1963 - 1965 Corvette: Service Bulletin: Air Gaps - Corvette Folding Top-To-Body Panel

Bulletin Number: TSB #1097, Section I

Date: February 11, 1965

FIGURE 1 - REAR BOW WEATHER SEAL DETAILS

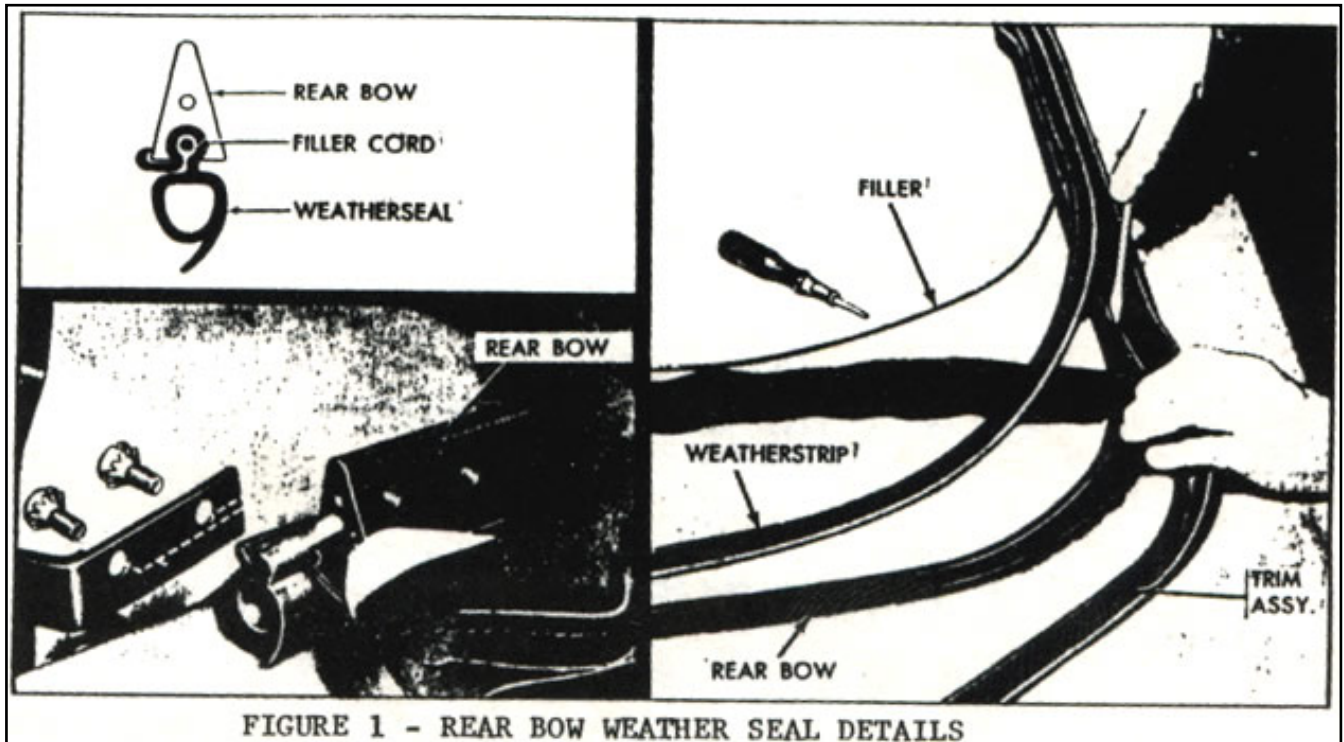
Corvettes, with folding top, may exhibit excessive gaps between rear bow weatherstrip and body panel in right and left rear quarter areas. These gaps are frequently sufficient to permit objectionable air and water entry and may be encountered on 1963-64 and early 1965 units.

A new weatherstrip which incorporates a seal with 1/4" greater height entered production effective with Serial #S108326.

The rear bow weatherstrip is retained in the bow by the installation of a filler cord which causes the upper bead of the weatherstrip to expand within the retainer channel (Figure 1).

Field complaints on this condition can be corrected by installation of the new weatherstrip, Part No. 3873761, per attached instructions.

1. Remove the weather seal by first removing the filler cord and then pulling the seal from the retainer channel of the bow.
2. Install the new seal by starting at the middle of the bow and the middle of the seal and work outward in both directions. The center portion of the seal should be installed dry to anchor the seal while installing the remaining portions. Apply liquid soap or silicon spray to the top of the seal to aid installation. Lubricate and work with no more than 12" section of the seal at a time, alternately from right to left side.
CAUTION : Do not stretch the weatherstrip on installation as this will cause distortion and poor sealing.
3. Lock the weatherstrip by installing the filler cord.
